FORMAL PLANNING OBJECTION

Planning Application: 41 North Hill, London N6 4BS

Proposed Second Floor Extension and Associated Alterations

Submitted on behalf of the occupiers of Nos. 43/45 North Hill

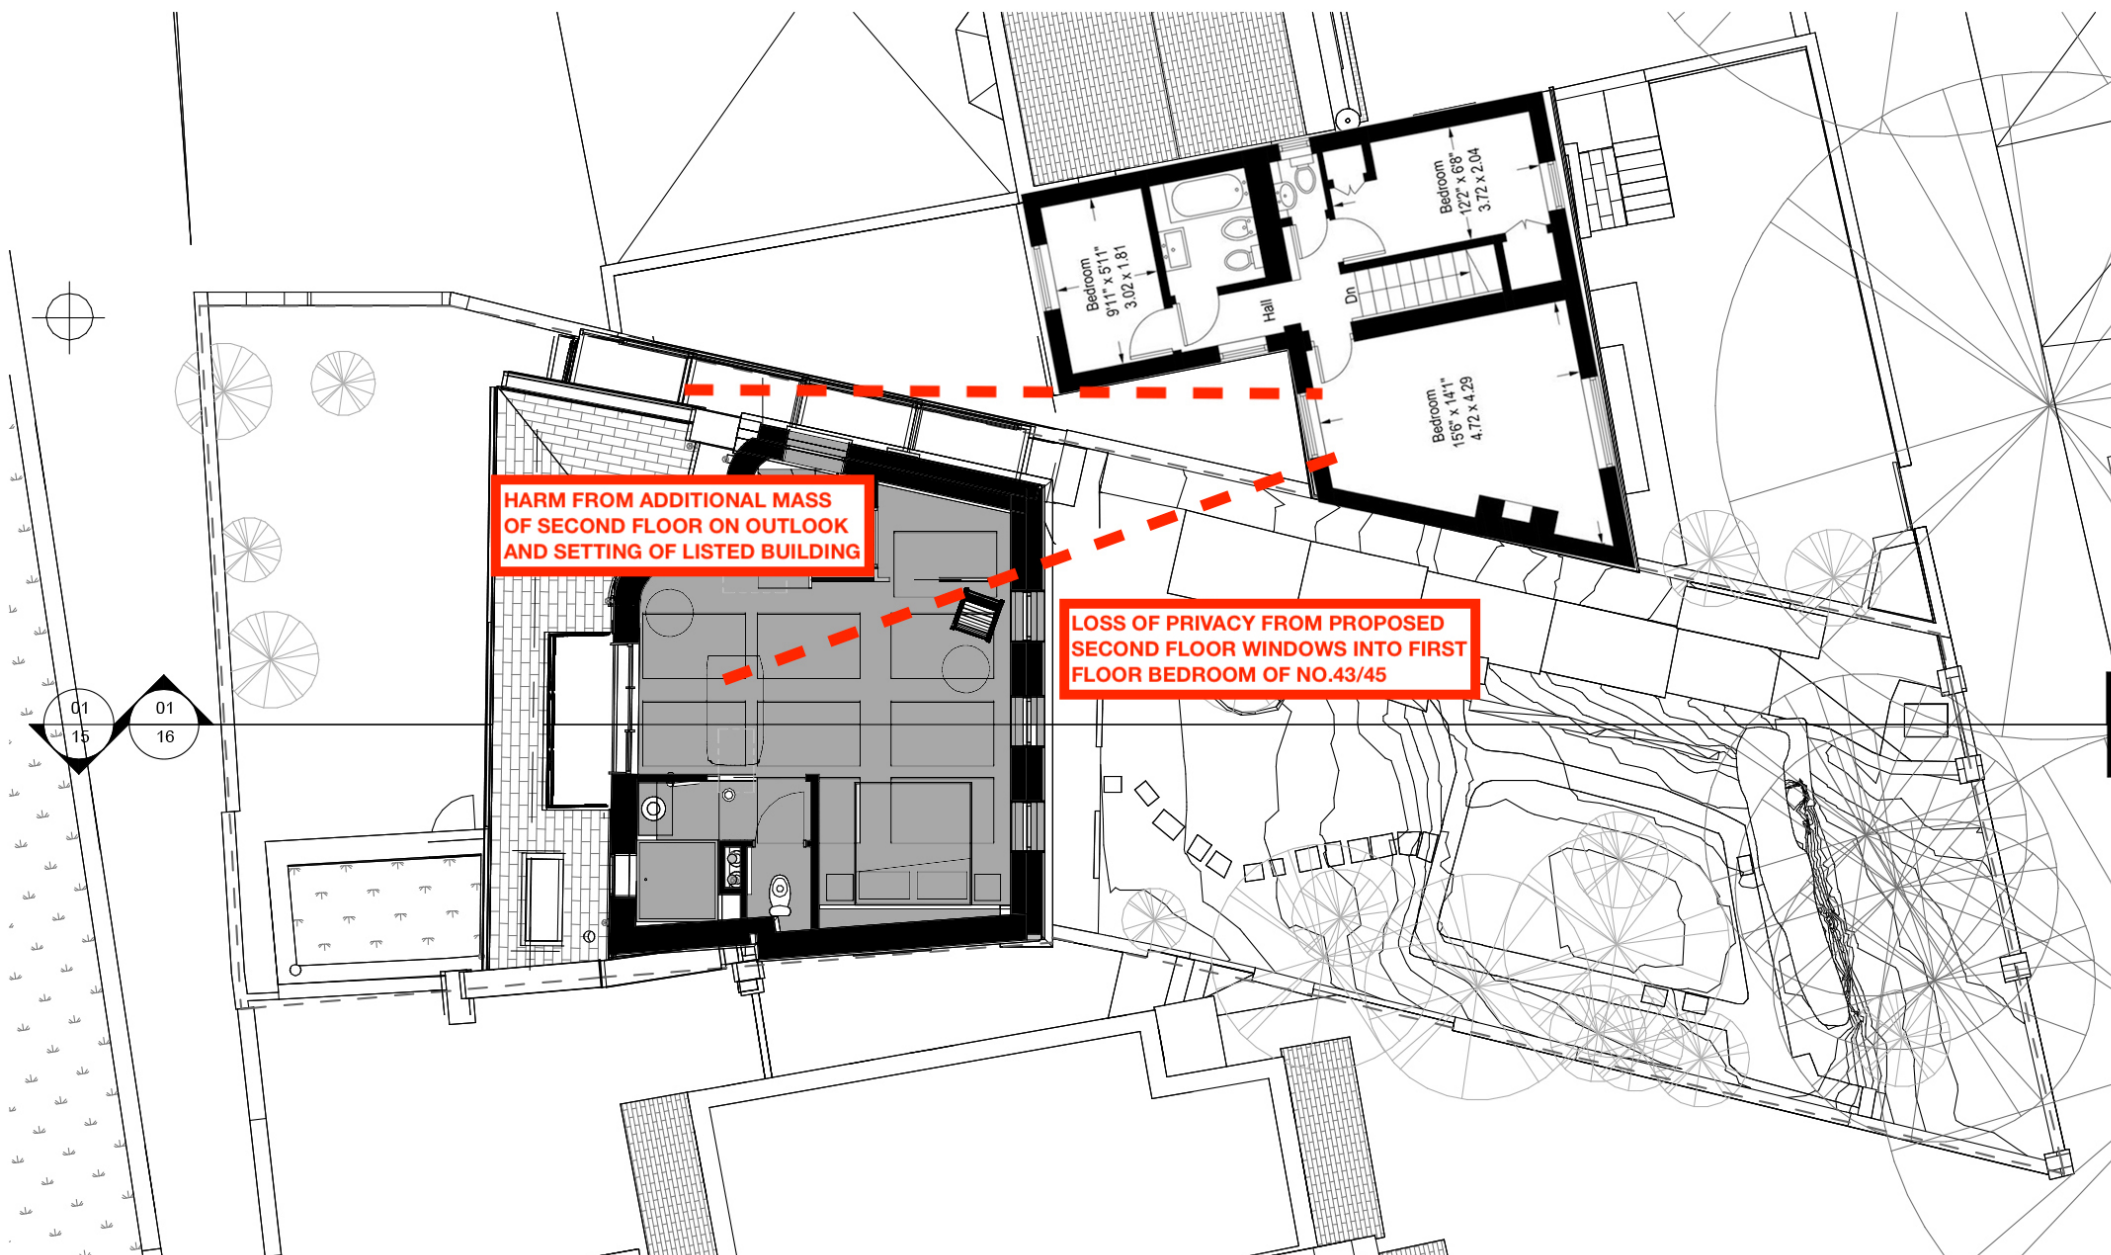
**HARM FROM ADDITIONAL MASS
OF SECOND FLOOR ON LIGHT & OUTLOOK
AND SETTING OF LISTED BUILDING**

**LOSS OF PRIVACY FROM PROPOSED
SECOND FLOOR WINDOWS PRIVATE
REAR AMENITY COURTYARD**

**HARM FROM ADDITIONAL MASS
OF SECOND FLOOR ON OUTLOOK
AND SETTING OF LISTED BUILDING**

**LOSS OF PRIVACY FROM PROPOSED
SECOND FLOOR WINDOWS INTO FIRST
FLOOR BEDROOM OF NO.43/45**
